**COUNCIL ACTION FORM**

**REQUEST:** INTEGRATED SITE PLAN SUBDIVISION PRELIMINARY PLAT AND MAJOR SITE DEVELOPMENT PLAN FOR 1404, 1405, AND 1410 BUCKEYE AVENUE WITHIN THE SOUTHWOOD SUBDIVISION (FORMER KMART SITE)

**Proposed Preliminary Plat and Major Site Development Plan  
1404, 1405, and 1410 Buckeye Avenue**

DESCRIPTION	
DATE	
SCALE	AS SHOWN
PROJECT No.	092615000
CHECKED BY:	RP
DESIGNED BY:	CPR
DRAWN BY:	EJK
SEAL	
<b>HORIZONTAL CONTROL PLAN</b> <b>SHOPPES ON SOUTH DUFF</b> <b>AMES, IOWA</b>	
<b>PRELIMINARY</b> <b>FOR REVIEW ONLY</b> <b>NOT FOR CONSTRUCTION</b> 	
SHEET <b>C3.30</b>

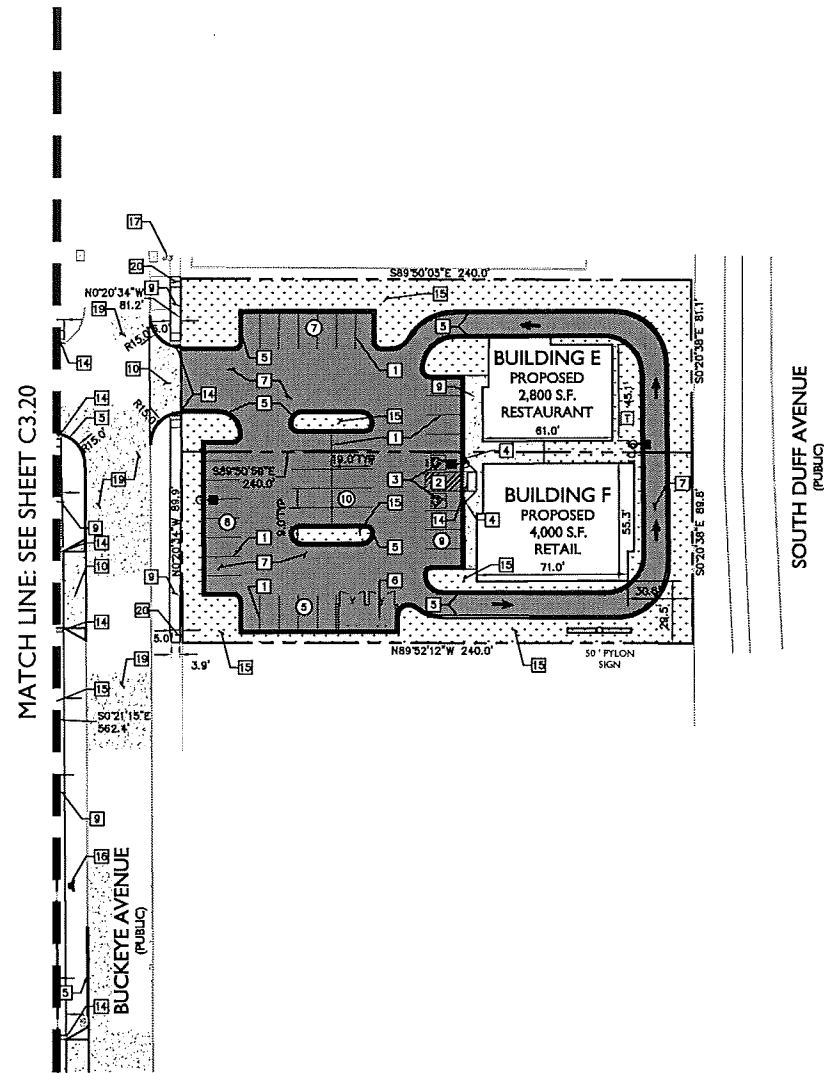
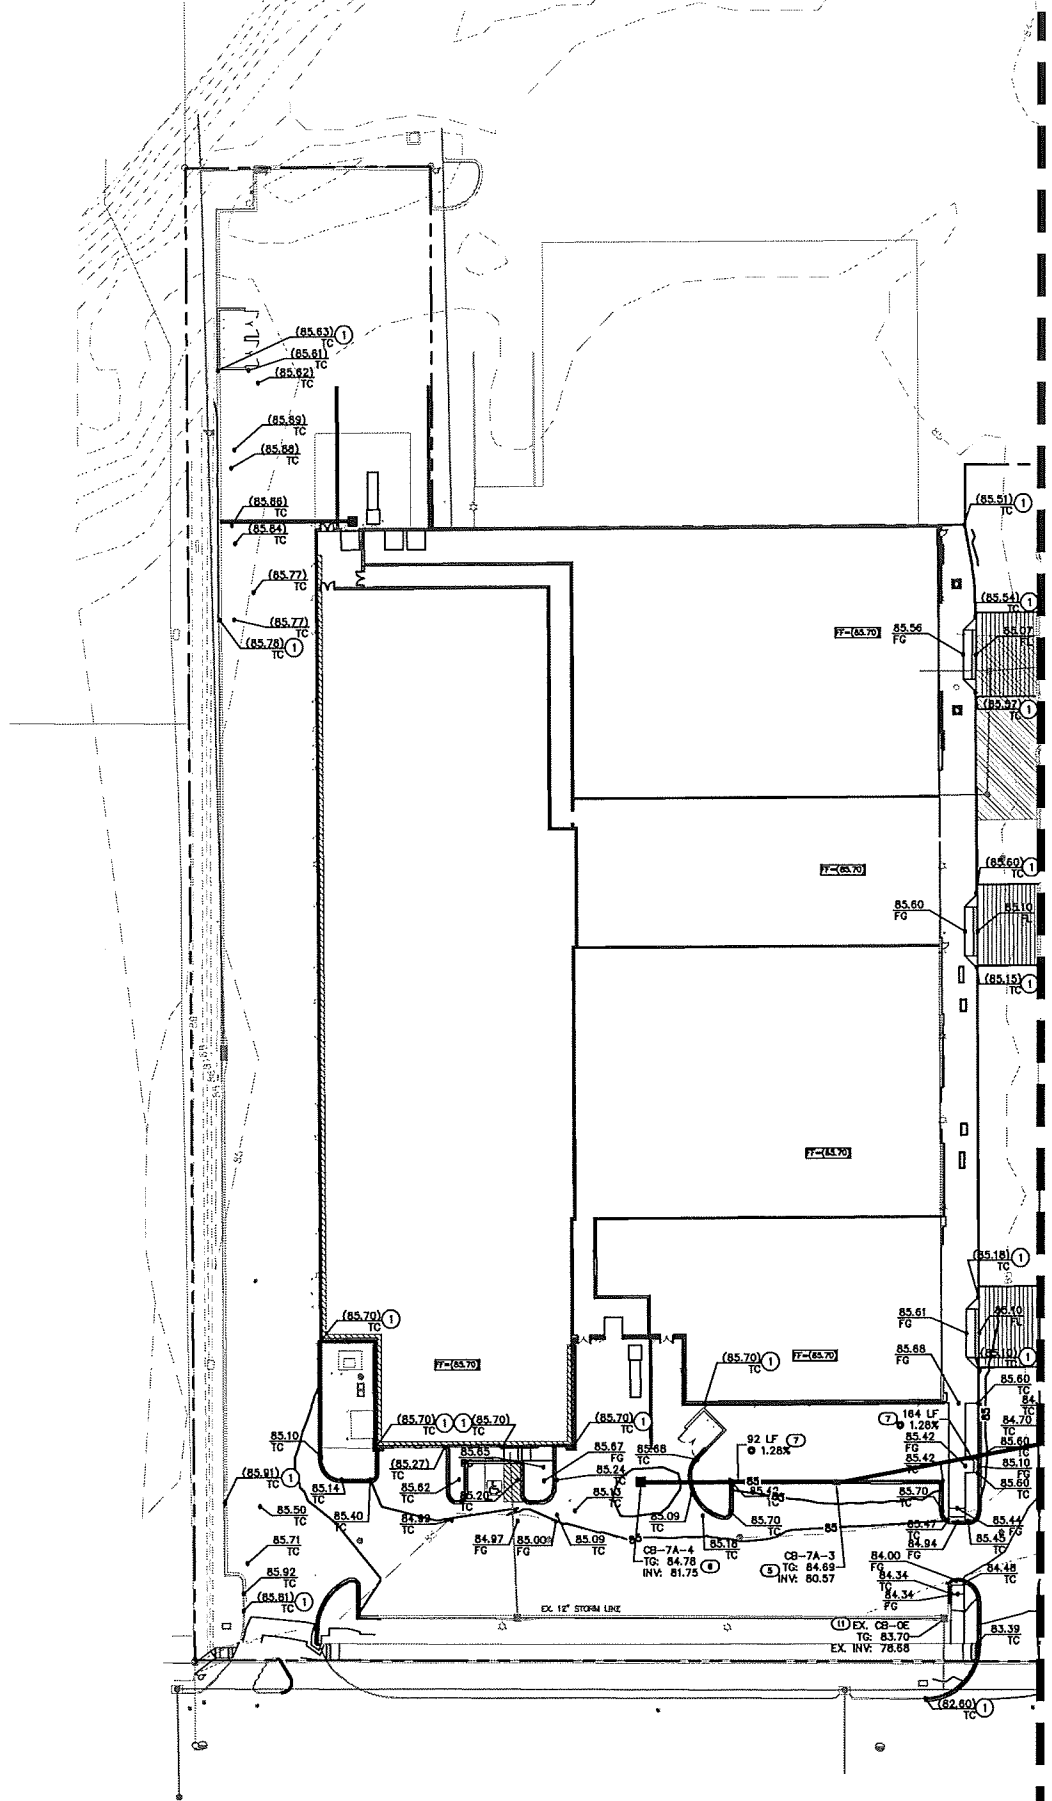
**The applicant’s plans include 587 parking spaces to serve the combined development. This amount exceeds the amount of required parking by 15 stalls based upon the applicant’s proposed mix of uses, if the Special Use Permit for the mini-storage facility is approved.** Staff estimates the proposed mix of retail and restaurant uses without the storage use would require at least 653 stalls with the mini-storage area calculated as parking for allowed display store/wholesale trade uses at a 1/500 parking stall/square feet. **In the event the Special Use Permit is not approved, the use mix or the amount of total square footage would need to be adjusted to reduce required parking by approximately 66 spaces.** This issue is noted on the plans and staff has included a condition regarding the required parking spaces and limits uses.

- ii. The allowed amount of tenant restaurant square footage or total retail space will be reduced, or a combination of both, to match the amount of parking provided within the site, as indicated in the note included on the site plan (Sheet C3.00)

\*\*\* SITE IS LIMITED TO APPROXIMATELY 13,300 SQUARE FEET FOR RESTAURANT USES, SUBJECT TO CONSISTENCY WITH THE CITY PARKING RATIOS AND ASSUMING APPROVAL OF CLIMATE CONTROLLED MINI-STORAGE. IN THE EVENT THE CLIMATE CONTROLLED MINI-STORAGE IS NOT APPROVED, THE MIX OF USES WILL BE MODIFIED TO THE LESS CORRESPONDING AMOUNT OF AVAILABLE PARKING, APPROXIMATELY 66 LESS PARKING SPACES.\*\*\*

Building D | Floor Plan

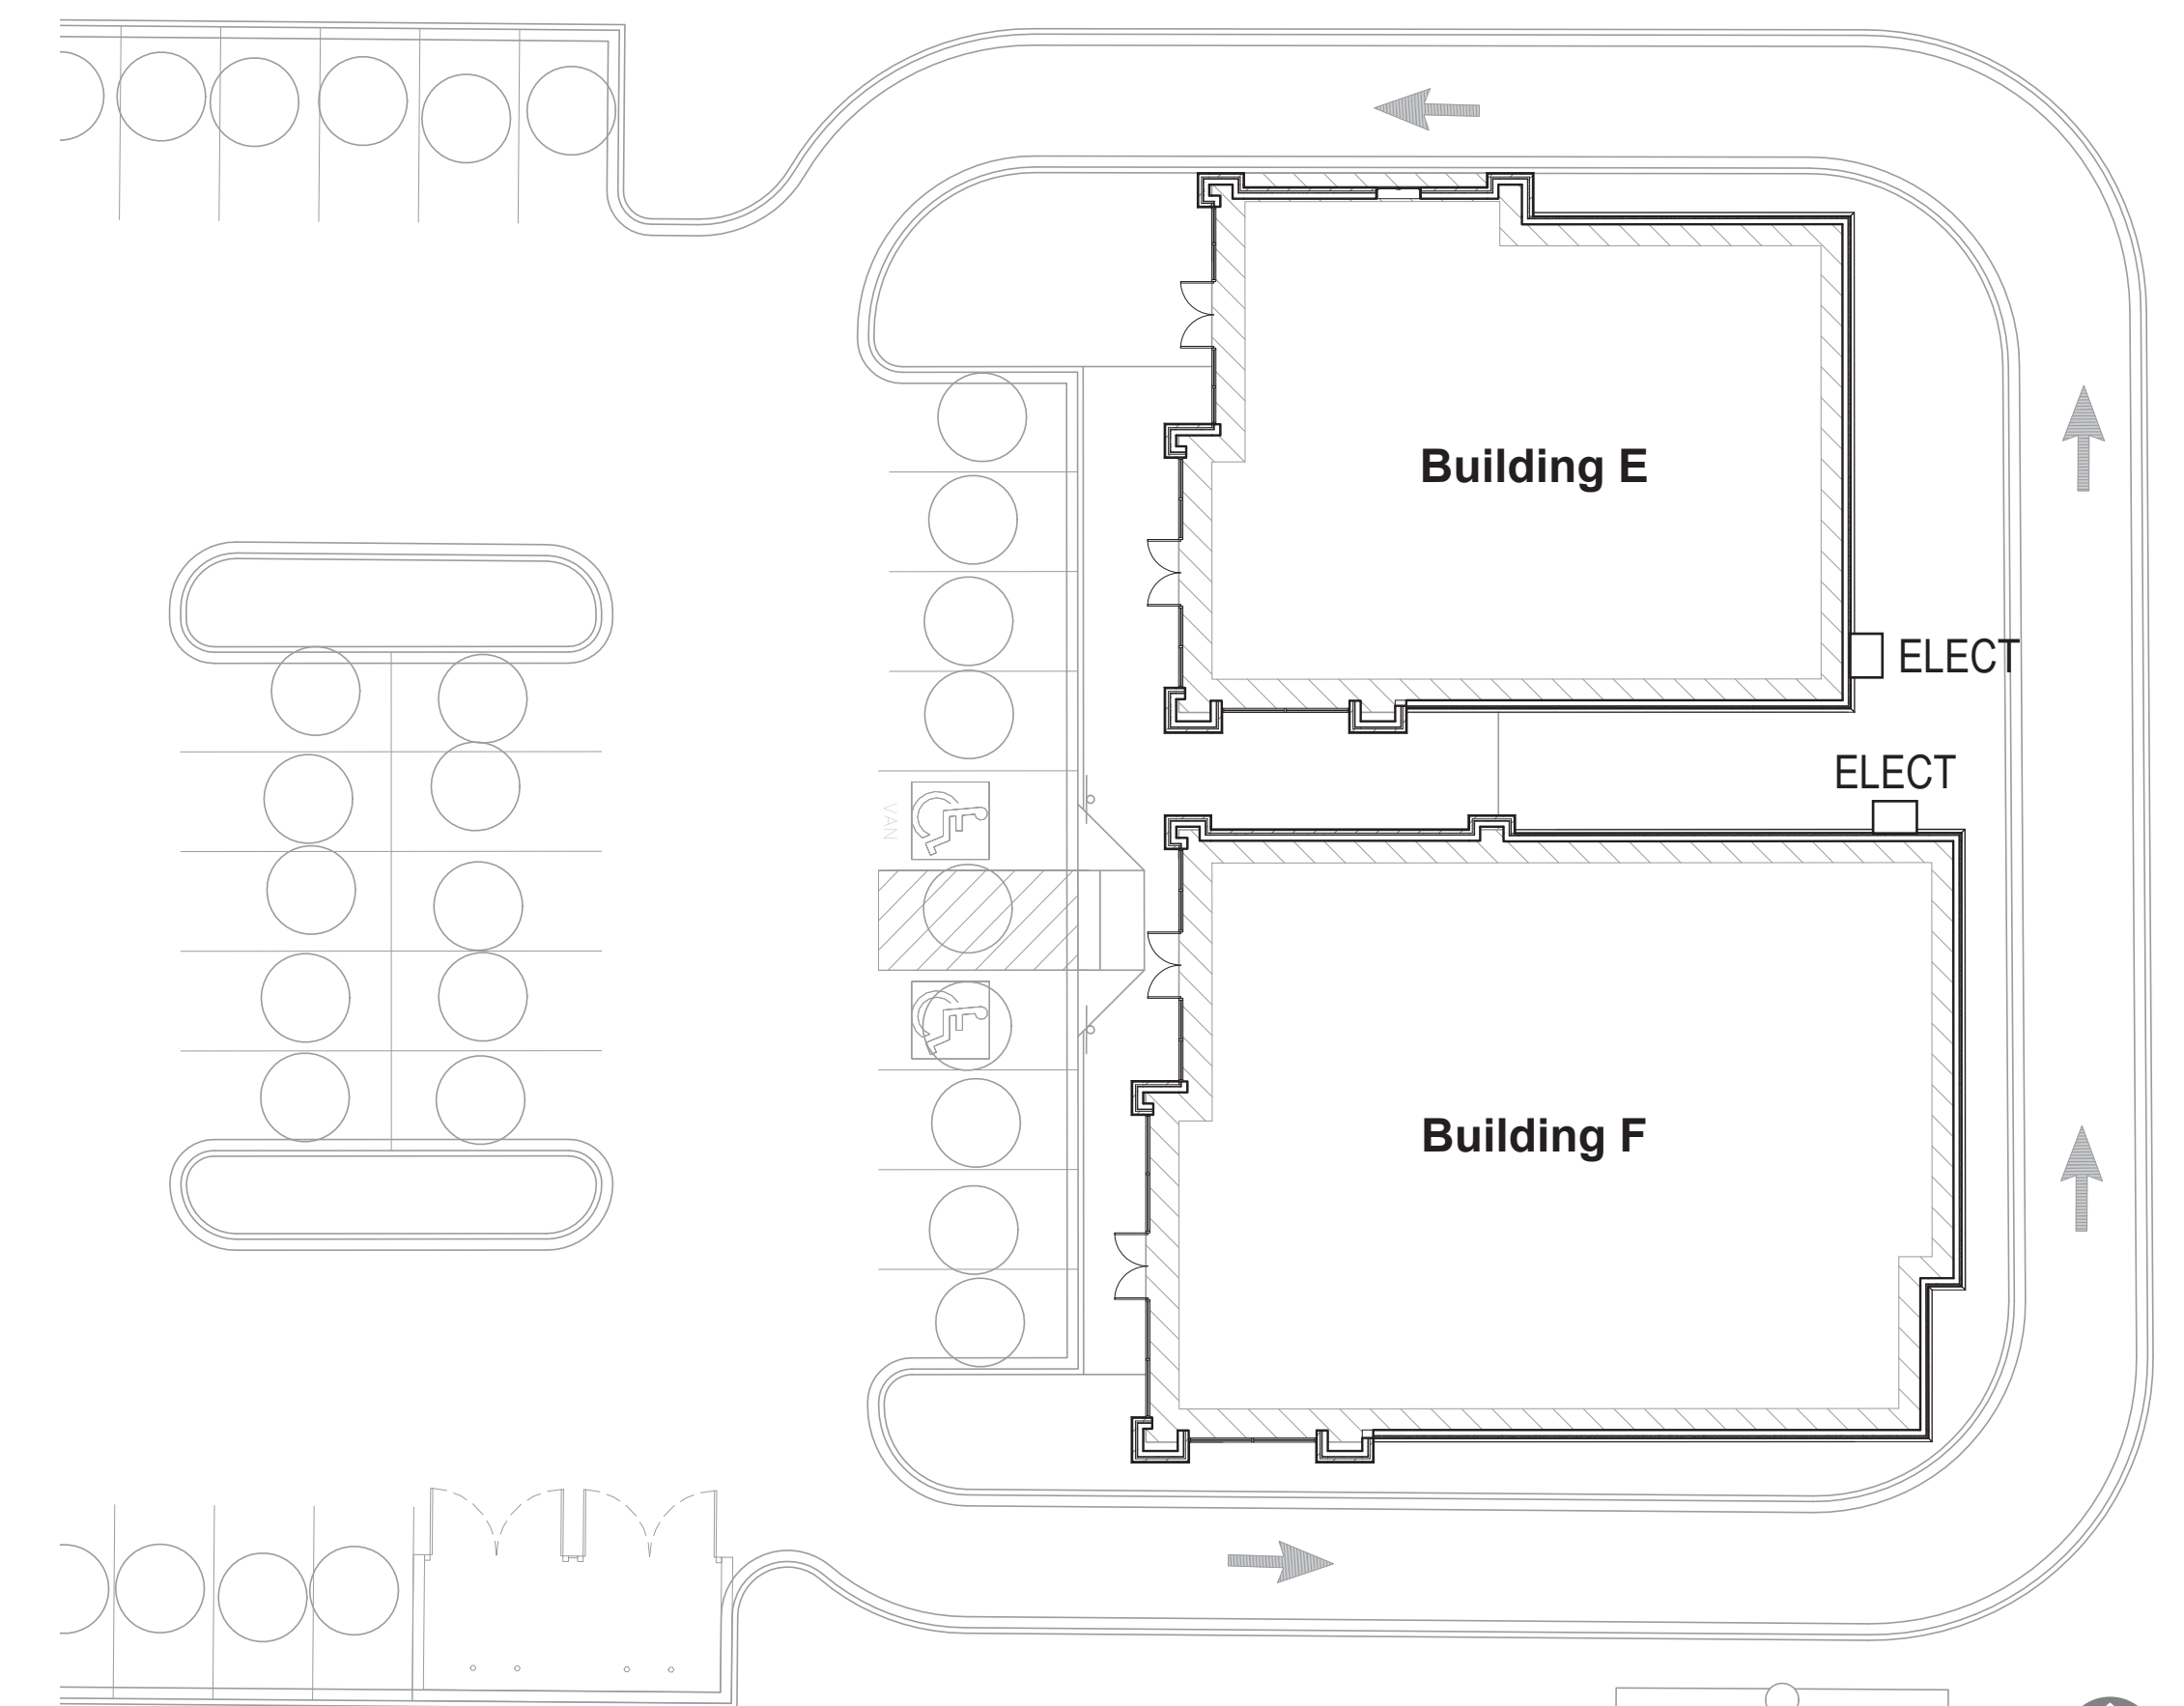
- iv. Recording of easements for public utilities as noted on the site plan prior to occupancy of buildings.
    - v. Include a note on the plan to modify the design of Building D for a drive through use to only have a pick-up window on the east side of the building and the location of menu board located along the south side of the site to create optimal queuing capacity within Lot 5. The revisions are subject to Planning Director approval.

Building "D" indicates a drive thru use will be located on this lot. Stacking usually occurs at the menu board where orders are taken. Staff is concerned that peak queuing could block circulation if not sited correctly. The building layout was adjusted on the site plan to indicate that a pick up window would be located on the east side of the building as requested by Staff. Staff requested the pick-up window to be located on the east side of the building with a menu board located as far from the drive thru entrance as possible to prevent stacking to back up into parking lot drive aisles and blocking parking stalls.
